Item 11.**Development Application: 683-689 George Street, Haymarket - D/2024/1066****File Number: D/2024/1066****Summary**

Date of Submission:	The application was lodged on 22 November 2024. The application has been modified by way of amended drawings during assessment.
Applicant & Architect:	Wardle Studio
Owner:	Posei Pty Ltd.
Planning Consultant:	Ethos Urban
Heritage Consultant:	GBA Heritage
Design Advisory Panel:	The application was considered by the City's Design Advisory Panel on 13 February 2025. The application has been amended in response to comments received from the Panel.
Cost of Works:	\$86,058,500
Zoning:	The site is zoned SP5 - Metropolitan Centre under the Sydney Local Environmental Plan 2012. The proposed development comprises works that will facilitate future commercial, retail and community uses that are permissible with consent in the zone.
Proposal Summary:	Approval is sought for the retention of existing basement levels, alterations to the first 5 levels of the building and construction of 8 additional levels, resulting in a 13 storey mixed-use development. The proposal provides for indicative future land uses, including commercial offices, retail, medical and

Figure 10: Original and amended architectural drawings (north elevation) showing an overall simplification of the building facades

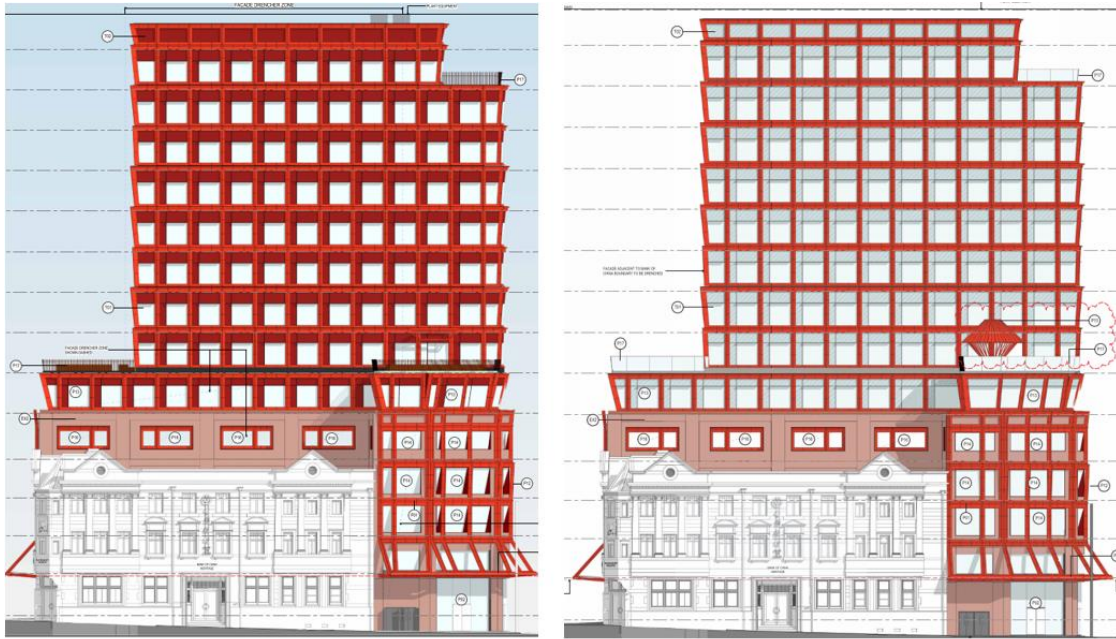
- (a) architectural drawings have been amended in response to comments received from the City's Design Advisory Panel and Council's urban designer:
 - (i) to reduce visual impacts, particularly in relation to the heritage listed Bank of China Building, the interface between the existing and new building facades has been simplified at the George and Hay Street frontages (refer to the Discussion section below - response to Design Advisory Panel)

Figure 11: Original and amended east elevation plan showing a simplified building design. A 2 metre tower setback to the Bank of China Building has been provided (northern boundary)

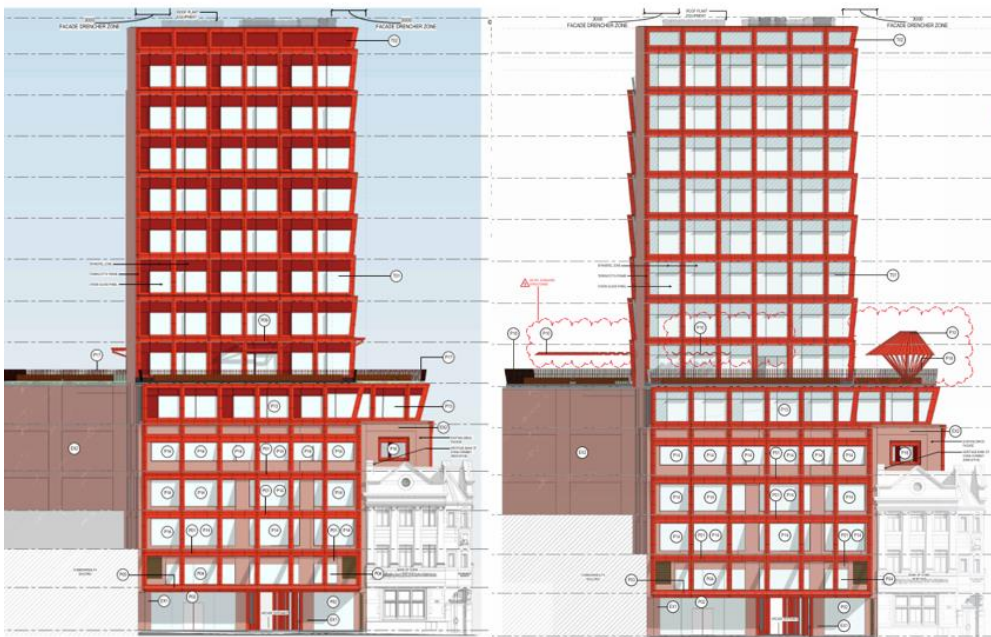
- (a) the new tower addition has been setback by 2 metres from the northern property boundary to allow for the maintenance of the facade to be undertaken from a building maintenance unit fully within the site boundary. This is in relation to there being no easement for maintenance access over the adjoining land (Bank of China Building).

Figure 43: Proposed height of building (including roof plant)

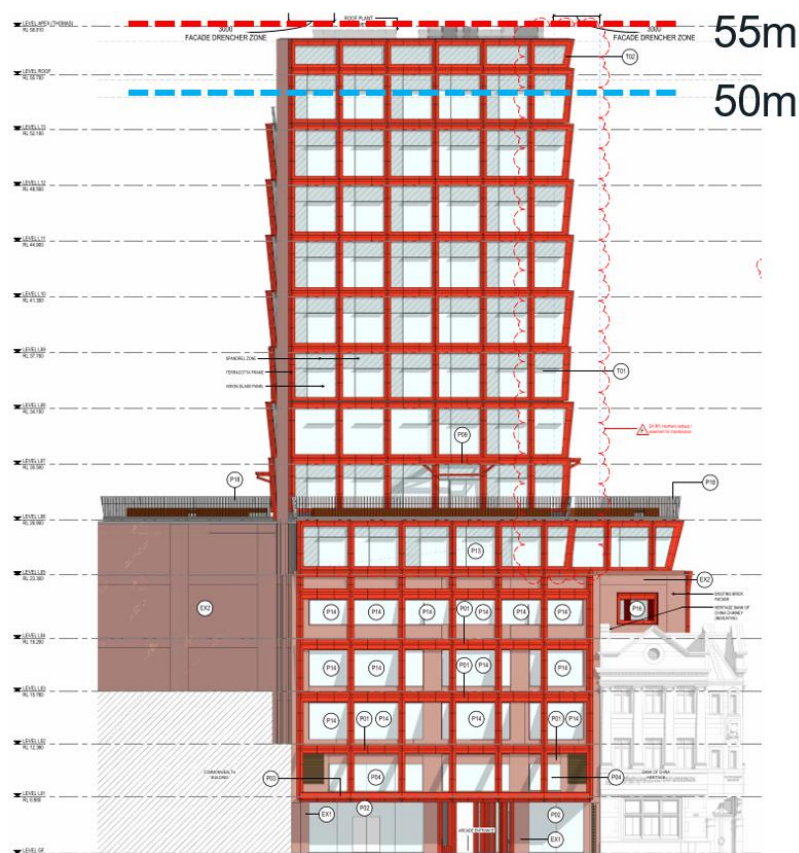
50. In accordance with the provisions of Clause 4.3 of the SLEP 2012, the site is subject to a maximum height of buildings control of 50 metres. The development proposes a maximum height above ground level of 55 metres and exceeds the standard by 5m (10% - Figure 43 below).

- (b) Clause 4.3 objective (b): The part of the building that exceeds the height of buildings standard will not have any significant impacts for the adjoining Bank of China Building. The tower addition as a whole has been set back a further 2 metres from the northern boundary, thereby reducing its scale. Other changes have been made to the building facades, including to the upper level of the building above 50 metres. Refer to the response to DAP comments above.

Figure 44: Facade design at the corner of Hay and Thomas Streets, including the existing condition (left), the development as lodged (middle) and as modified in response to DAP comments

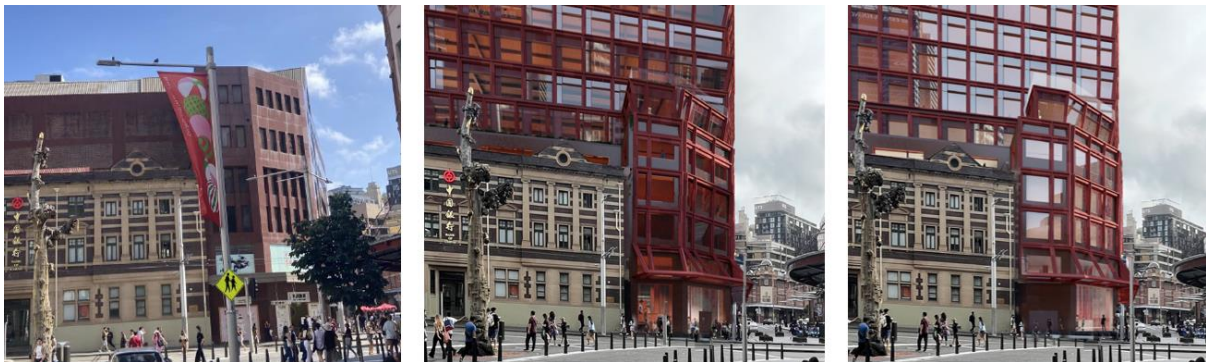
60. The proposal was amended in response to comments and design input provided by the City's Design Advisory Panel (DAP).
61. The DAP recommended that the facade and awning design should be simplified and calmed, particularly around the interface with the adjoining Bank of China building. The DAP recommended a clearer differentiation between podium and tower, reduced angled facades in the podium and that the architectural grid overlay should be more referenced to the existing geometries of the building.

- (a) Amended drawings address the issues raised by DAP. The building presentation has been calmed at the corner of Hay and Thomas Streets by simplifying facade grid where it interacts with the Bank of China Building. The building edge has been straightened up to level 6 and facade grid lines have been centred on the arcade entries of George and Thomas Streets. Where windows in the podium were previously angled, they are now vertical, providing simplified geometries. Refer to Figure 44 below.

- (b) Footpath awnings at the street level have been redesigned. Where clear horizontal glazing was originally proposed above the footpath level, amended drawings now show opaque or fritted glass for the first two thirds of the awning adjacent to the building, with a gradient to clear glass closer to the kerb. The solid design will reduce the visual impact of any debris and dirt across the awning while providing daylight and a view to the sky. The applicant has also identified the spaces within the awnings as potential locations for public art, in line with an amended preliminary public art strategy.

Figure 45: Solar impacts to facades reduced by spandrels, shade fins and high performance glazing

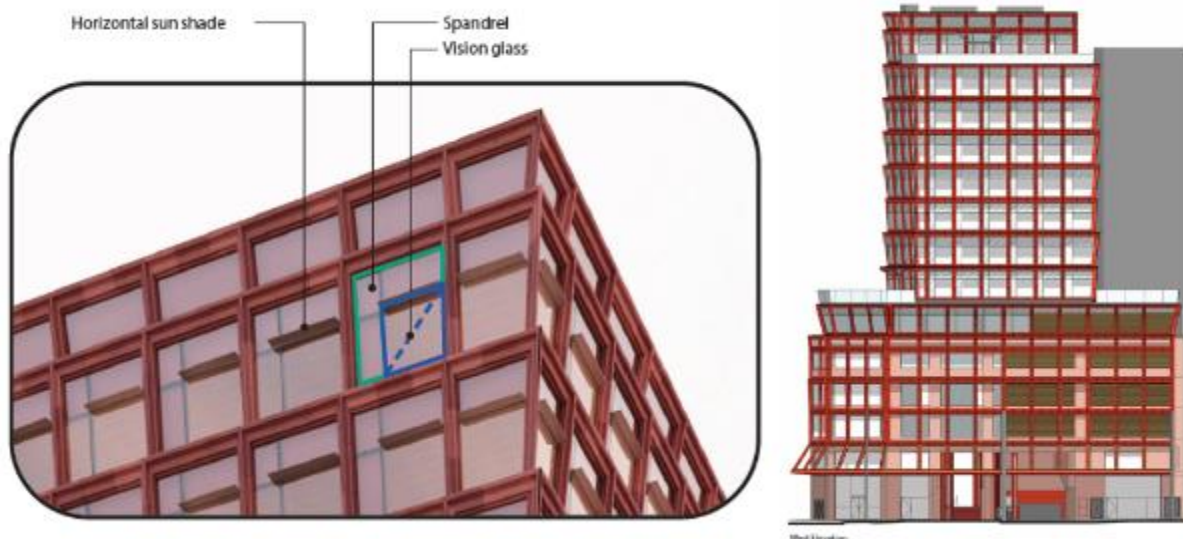
63. The Design Advisory Panel recommended that the size and orientation of sun shading fins in the tower should be reviewed to ensure they are effective and that further consideration be given to the design landscape terraces to ensure that they are comfortable and usable.

- (a) The applicant has provided a design response showing improved efficiency in relation to the sun shading of building facades. Insulated vertical and horizontal spandrels have been provided for all windows that reduce the overall glazing extent. Fins are provided externally to the building to reduce solar impact and where this is unavoidable, late in the day, high performance glazing is provided to reduce heat loads within the building.

- (b) The design response is acceptable to Council's urban design specialists, who have recommended a condition of consent requiring vertical fins be added to each glazing bay at the vertical mullion line which match the horizontal sun shading fin depth and materiality. The fins will ensure additional sun shading of the external elements of the building, noting the north-westerly aspect of the site.

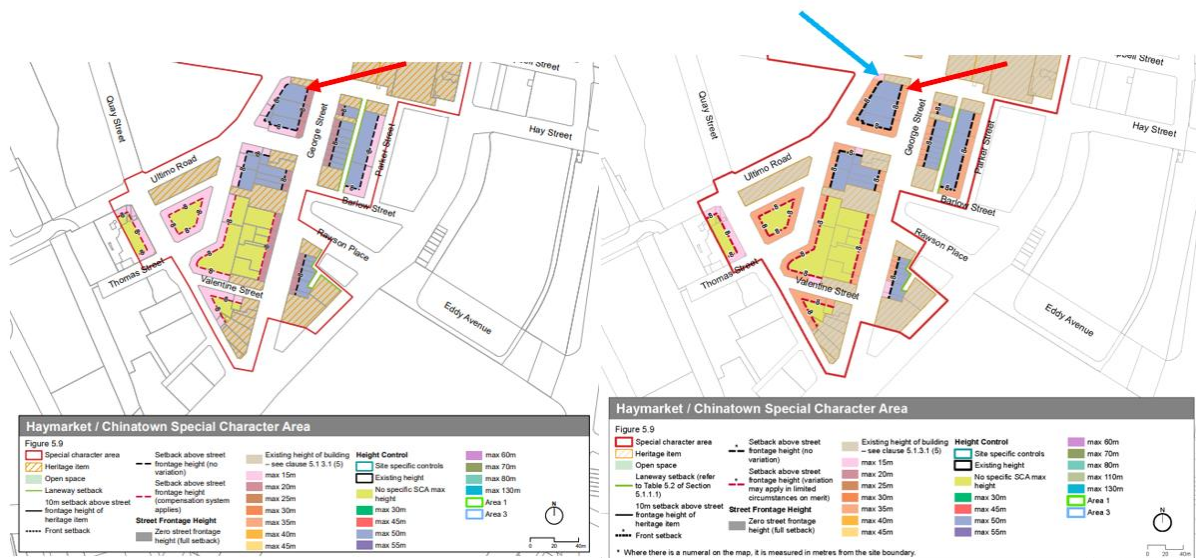
64. The development proposes to exceed the existing and draft SDCP 2012 controls in relation to street wall heights and setbacks above street wall heights (see Figure 46 below):

- (b) **draft** SDCP 2012 controls require a setback of 8 metres above a street wall height of 35 metres to both George, Thomas and Hay Streets.
65. In relation to the George Street frontage, the proposal exceeds the **current** controls (and satisfies the **draft** controls) as it involves the demolition of existing structure and the rebuilding of new fabric, reducing the street frontage height from 27.5 metres to 22.5 metres and setting back the new tower by 8 metres from the George Street frontage.

66. In relation to the Thomas Street frontage, the development proposes to exceed the **current** and **draft** controls in relation to setback and street wall height by providing a 5.7 metre setback above a 48.5 metre street wall height. Further, the proposal exceeds the 15m street wall height for a small section of the site at the corner of Hay and Thomas Streets, which is included in the current and draft controls (Figure 46, blue arrow).

67. The inconsistency with the controls can be supported in the circumstances of the subject development application for the following reasons:

Figure 48: 5.7 metre setback aligns with north-western corner of Commonwealth Bank site, however, exceeds the 8 metre setback control from Thomas Street

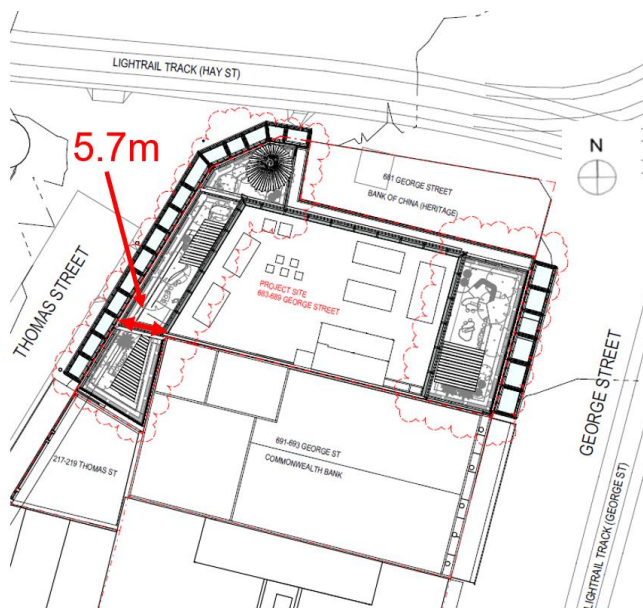
- (b) The resulting building is consistent with its surrounding context, noting the height and typology of buildings located within the visual catchment of the site. The proposal to set back the upper level of the building (Level 13) by 5.7 metres from the Thomas Street frontage (as compared to the 8 metres specified by the SDCP 2012), can be supported noting the setback aligns with the curvature of the unusually shaped site boundary at the south-western corner. That is, where it adjoins the north-western corner of 691-693 George Street (the Commonwealth Bank site) - Refer to Figure 48 below

Figure 49: Existing peak flood depths arising from the 100 Year Average Recurrence Interval flooding event

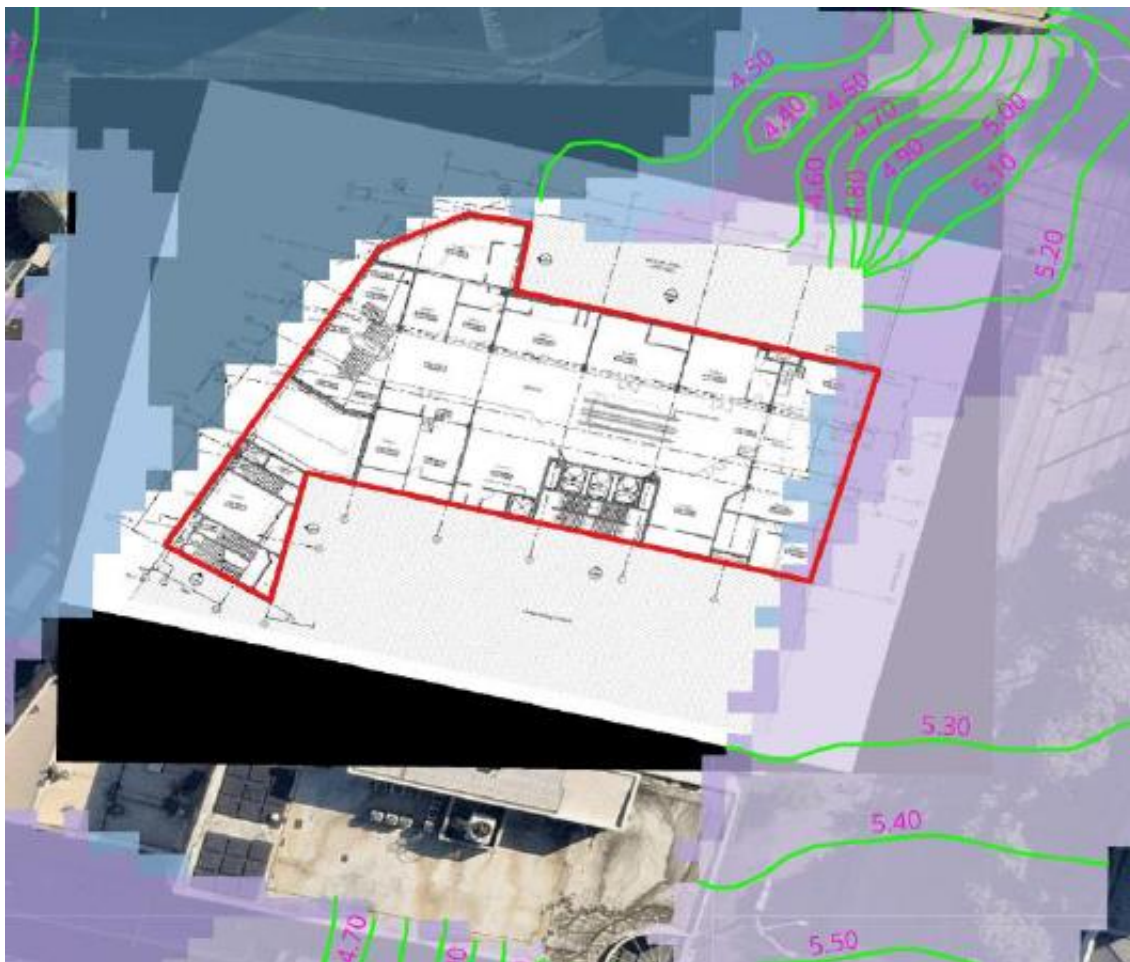
70. An amended flood impact and assessment report has been provided for assessment, which identifies flood levels around the site. All frontages of the site are affected during 100 Year Average Recurrence Interval flooding events with greater depths at the Thomas Street frontage (Figure 49 below).

Figure 50: Extract from flood response drawings, showing increased floor levels for through-site link and an automated flood barrier close to the George Street entry (hatched red). Further changes are proposed within retail tenancies with a frontage to Thomas Street.

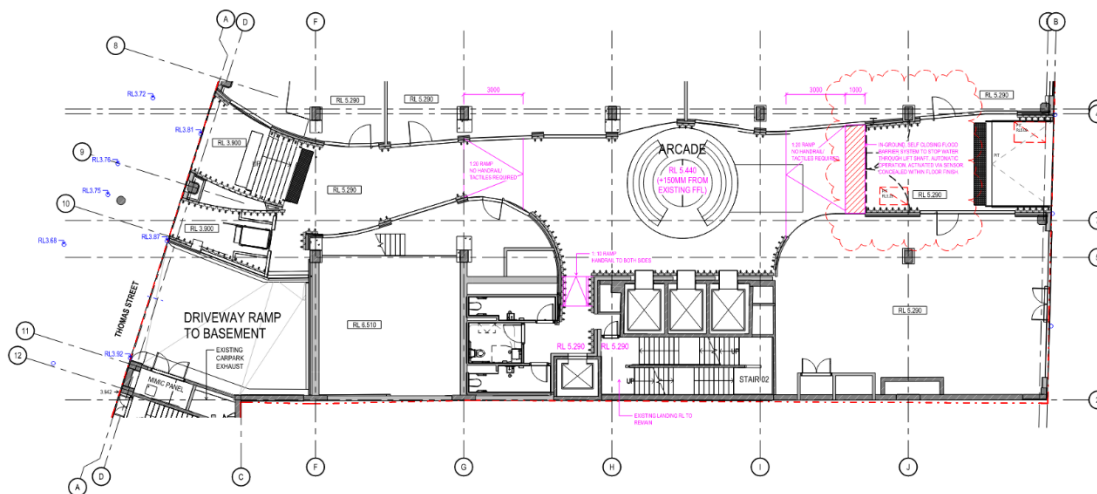
72. An amended flood impact and assessment report has informed architectural drawings that have been updated for assessment. The amended drawings show the following changes (Figure 50 below):

- an automated 'top-down' flood gate is proposed at the driveway entry, preventing flood waters entering basements
 - automated, internally hinged flood gates and flood windows (able to withstand pressure from flooding) are proposed within retail tenancies facing Thomas Street. Within retail tenancies, new stairs are to be provided, providing emergency egress to higher ground within the building from retail tenancies during severe flood events

- existing fire stairs are to be reconfigured at the western end of the site, enabling emergency egress from the basement into the ground level arcade during flood events.

73. While flood gates are generally discouraged, Council staff have recommended consideration be given to granting development consent to the development for the following reasons:
- the development involves the adaptive re-use of an existing building that currently does not meet the minimum flood requirements. Noting the site constraints, consideration can be given to installing suitable flood mitigation measures that will upgrade the existing building to meet the flood levels specified by the flood report

Figure 53: Separation distance between seat structure and lift entries

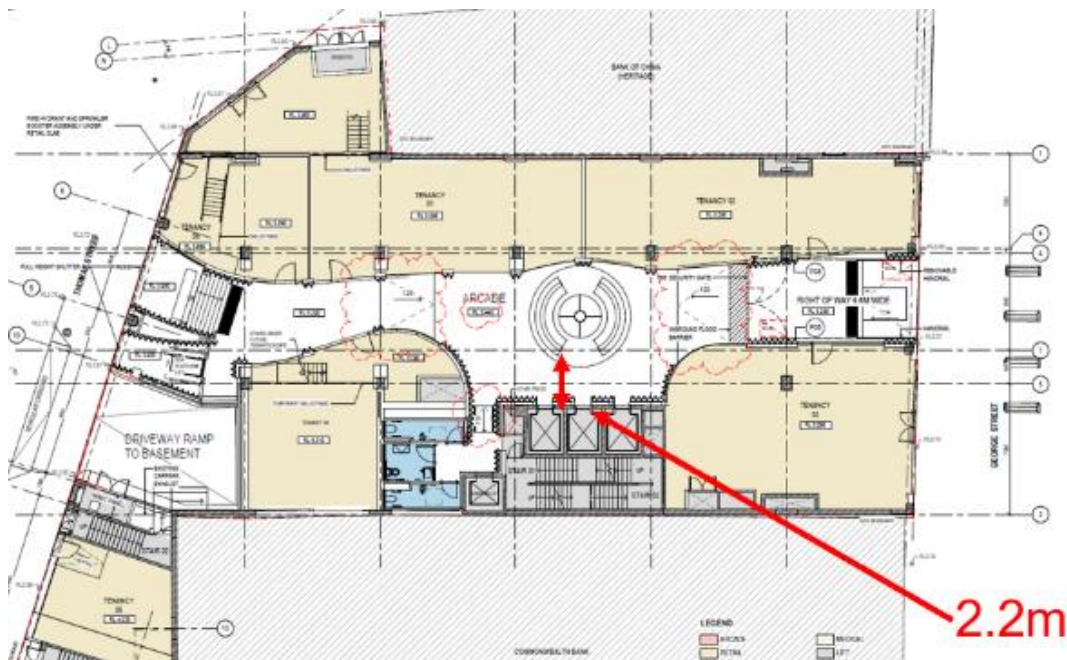
87. The existing link is proposed to be retained and embellished with a circular architectural seat structure close to the lift core. No detailed drawings have been provided with the application however the structure is identified in the ground level drawing (Figure 21 above) and the Preliminary Public Art Plan (Figure 52 below).

89. A condition is recommended that the seating structure must be redesigned, such that it retains a continuous effective width within the through-site link of 3m.

Figure 54: Proposed new openings for windows, northern elevation of existing building

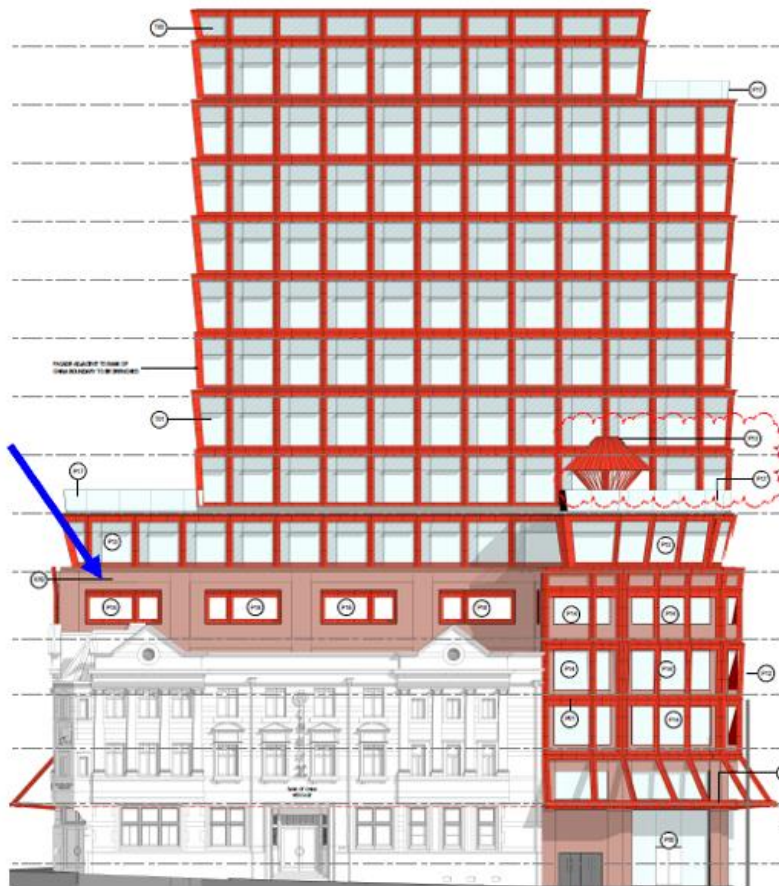
92. The applicant has provided a response in relation to four new windows that are proposed facing the northern boundary. These windows comprise new openings to existing building fabric above and facing the Bank of China Building (Figure 54 below). The applicant states the windows will be operable, providing for ongoing maintenance and that the windows are intended to be drenched externally, above the Bank of China Building.

93. This element of the proposal is not supported by Council staff on the basis there is no agreement from the owner of the adjoining site for new building elements (including drenchers) to be constructed over their property.

94. As such, a condition is recommended that the four new openings for windows must be deleted from drawings, prior to the issue of any construction certificate.
